# VICTORIAN CIVIL AND ADMINISTRATIVE TRIBUNAL

VCAT REFERENCE NO. P550/2024  
PERMIT APPLICATION NO.YR-2023/596

**APPLICANT** Storm Victor, John Magnik & Others  
**RESPONSIBLE AUTHORITY** Yarra Ranges Shire Council  
**RESPONDENT** Alex Gradwell  
**SUBJECT LAND** 4 Clive Court  
MOOROOLBARK VIC 3138  
**HEARING TYPE** Hearing  
**DATE OF HEARING** 12 March 2025  
**DATE OF ORDER** 26 March 2025  
**CITATION** Victor v Yarra Ranges SC [2025] VCAT  
257

Figure 2 Floor Plan.<sup>3</sup>

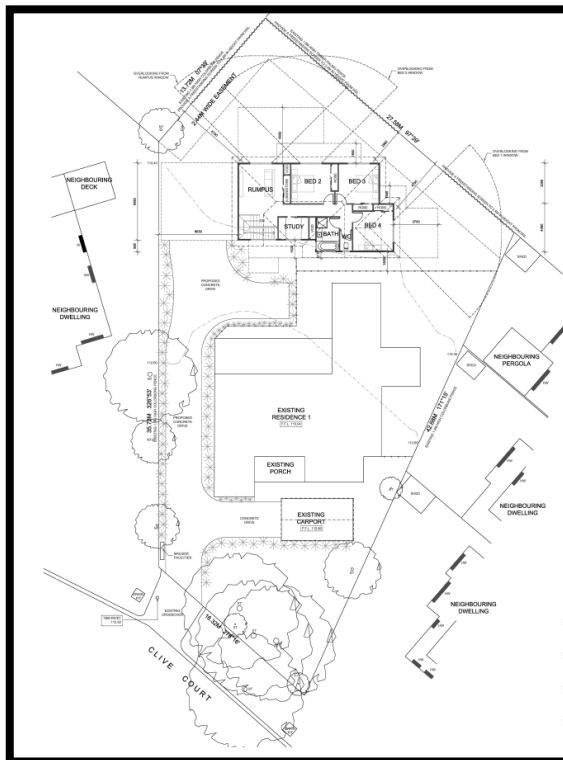
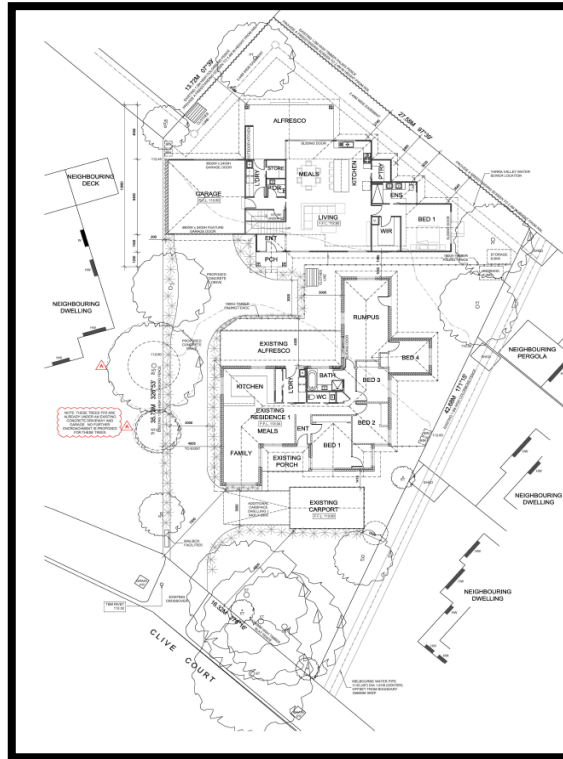
- 26 Council requested the materials to be changed to include brickwork. Whilst the NOD required this to be changed to the first floor, it became clear during the hearing that the change in materials is for the ground floor. Council says the use of cement sheet weatherboard at ground level does not respect the existing neighbourhood character given the surrounding dwellings incorporate brick at ground level. As such they requested this change in the NOD.

- 27 I am not persuaded that a change to the materials is necessary. The proposed dwelling is significantly setback from the front of the site, behind the existing dwelling and is largely concealed by the existing dwelling, except for the proposed garage. Even so, this is unlikely to be highly visible when viewed from Clive Court given the irregular shaped allotment. I do not share the same view as council on this matter and therefore deleted this condition.

- 37 The applicant was also not persuaded that the alfresco area adjoining his property will not overlook his backyard. As demonstrated in the ground floor plan below, the angle of the allotment has the alfresco area setback from the pointiest section of the land by 12 metres.<sup>7</sup> The proposed 2.4 metres high screen will limit any overlooking from the alfresco area, even with the decking area 300mm above finished floor level. I am satisfied Standard B22 is met.

Figure 4: Overlooking plan.<sup>5</sup>

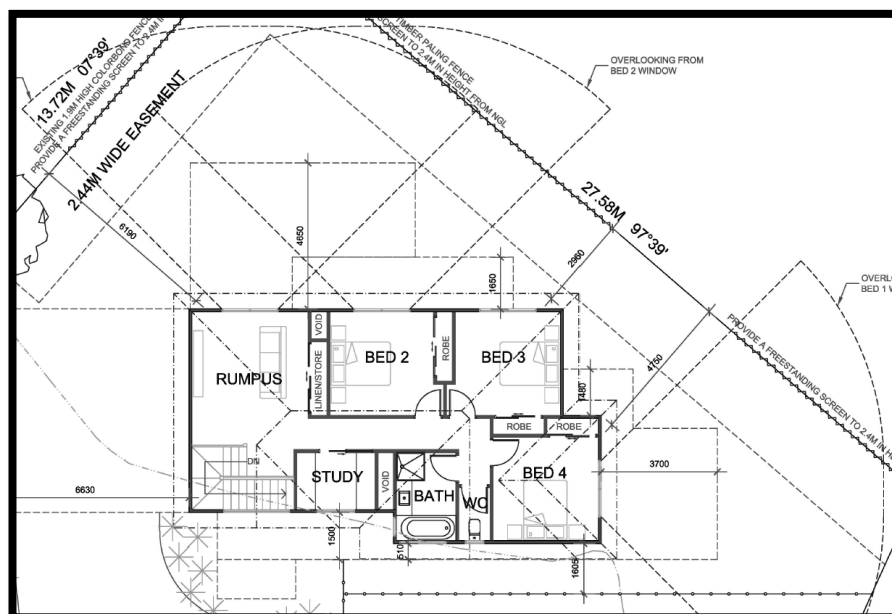
- 34 Bedroom 3 window is proposed to be screened with obscure glass to 1.7 metres above finished floor level. The rumpus room, bedroom 2 and 4 windows will be clear glass but rely on the construction of a 2.4 metre high free-standing screen, within the property boundary, adjacent to the existing 1.8 metre high paling fence (north-eastern boundary) and 1.9 metre high colorbond fence (north-western boundary).
- 35 The respondent confirmed the section plans show the critical 9 metre horizontal distance from the first-floor habitable room windows and the downward viewing opportunity taken at a height of 1.7 metres above finished floor level. In each case, the single storey roof form at ground level, obscures the downward view within the 9 metre arc. That is the 9 metre arc includes some of the secluded private open space of the adjoining

properties at 18 and 20 Winifred Road and 32 Lancaster Road. The addition of the 2.4-metre-high free-standing screen obscures the downward view into these areas as demonstrated in the section plan below.

- (d) A notation stating “Provide obscure glass to 1700mm above FFL and fixed shut” on the first floor study window and bedroom 3 of Dwelling 2.
  - (e) Overlooking section plans corrected to show the corrected roof form and bedrooms. The section plans to include details of the 2.4-metre

high screen, notes to include it is a framed free-standing screen, not attached to the existing boundary fences and complies with Standard B22 of clause 55.

Figure 5: section plan demonstrating overlooking detail.<sup>6</sup>

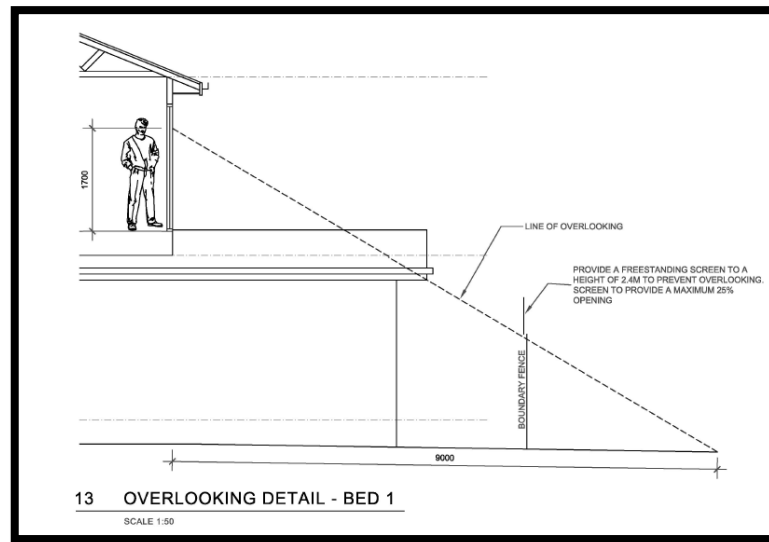
- 36 The applicant was not satisfied that the proposed screen will limit overlooking into his private open space and was concerned about the overlooking into their bedroom windows. However, this is beyond the requirements in Standard B22 of clause 55. I am unable to request the permit applicant to provide any further screening of these windows that is beyond the scope of Standard B22. I am satisfied the objective is met and measures have been included in the proposal to limit views into existing secluded private open space of the applicant's properties as outlined in the requirements in Standard B22.

- 11 Before the development is occupied, screening must be erected in accordance with the endorsed plans on the north-eastern and north-western boundary to an overall height of 2.4 metres above natural ground level, to limit overlooking by the Dwelling 2 first floor habitable room windows, into the private open space areas of the adjoining residential properties (in accordance with Clause 55.04-6) to the satisfaction of the responsible authority. The screening must be framed, formed, and must be maintained at all times to the satisfaction of the responsible authority.
